UNITED STATES PATENT AND TRADEMARK OFFICE

Office Action Summary

10/529,154

DETAILED ACTION

FIG. A, as annotated by the Examiner: A Cooling Device

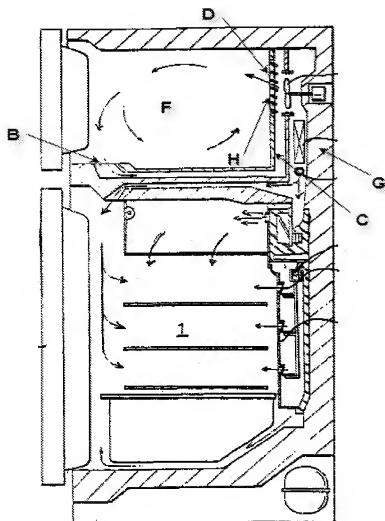
In reference to claim 1, Kim teaches a cooling device (FIG. 2) comprising a cooler (11, FIG. 2) provided on at least one side-wall side (G, FIG. A, as annotated by the Examiner) formed with a thermal insulating box (inherent in a freezer construction as shown in Kim, see FIG. 2); a cooling chamber (F, FIG. A) in front of the cooler (11, FIG. 2); and a fan (20, FIG. 2) that allows air in the cooling chamber to flow, wherein the cooler and the cooling chamber are partitioned by a partition (C, FIG. A) so as to allow cold air to be accumulated in the cooler, the fan (20, FIG. 2) is disposed on a side of the cooler (11, FIG. 2) relative to the partition (C, FIG. A), the partition in front of the fan (20, FIG. 2) has an aperture (D, FIG. A) formed in a flat sheet portion (above and below partition C, FIG. A), an open space is formed between the fan and the flat sheet portion in which the aperture is formed (see FIG. 2), cold air accumulated in a space inside the partition, and hot air in the cooling chamber are exchanged by the fan (20, FIG. 2) through the aperture (D, FIG. A), wherein the rotation of the fan generates a discharged flow of cold air discharged from the cooler to the cooling chamber through the aperture and a sucked flow of cold air sucked from the cooling chamber to the cooler through the aperture, and the discharged flow and the sucked flow directed from the cooling chamber to the cooler collide with each other in a portion in which the aperture is provided (inherent in the structure as described in Kim, see FIG. 2), but does not teach that the perimeter of the fan is not surrounded by a cylindrical component, and the open space is formed outside the fan in the radial direction. Lazar teaches a forced convection evaporator (FIG. 3) wherein a fan (58, FIG. 3) is located inside the casing (2,

In reference to claim 2, Kim, Lazar and Clark disclose the cooling device as explained in the rejection of claim 1, and Kim also teaches that dimensions of the aperture (D, FIG. A) are larger than a diameter of the fan (20, FIG. 2).

In reference to claim 3, Kim, Lazar and Clark disclose the cooling device as explained in the rejection of claim 2, and Kim also teaches that when viewing the fan (20, FIG. 2) in a

direction of a rotation shaft of the fan, the fan is disposed in the aperture (D, FIG. A) and there is an open space outside the fan (in front and around of fan 20, FIG. 2).

In reference to claim 5, Kim, Lazar and Clark disclose the cooling device as explained in the rejection of claim 1, and Kim also teaches that the discharged airflow and the sucked flow collide with each other, thus suppressing the flow speed of the cold air (inherent in the structure as described in Kim, see FIG. 2 and FIG. A).

In reference to claim 8, Kim, Lazar and Clark disclose the cooling device as explained in the rejection of claim 1, and Kim also teaches that a slit (B, FIG. A) is formed in the partition (C, FIG. A) at a portion below the cooler (11, FIG. 2).

In reference to claim 10, Kim, Lazar and Clark disclose the cooling device as explained in the rejection of claim 1, and Kim also teaches that a safety cover (grille H, FIG. A) is disposed over the fan aperture (D, FIG. A).
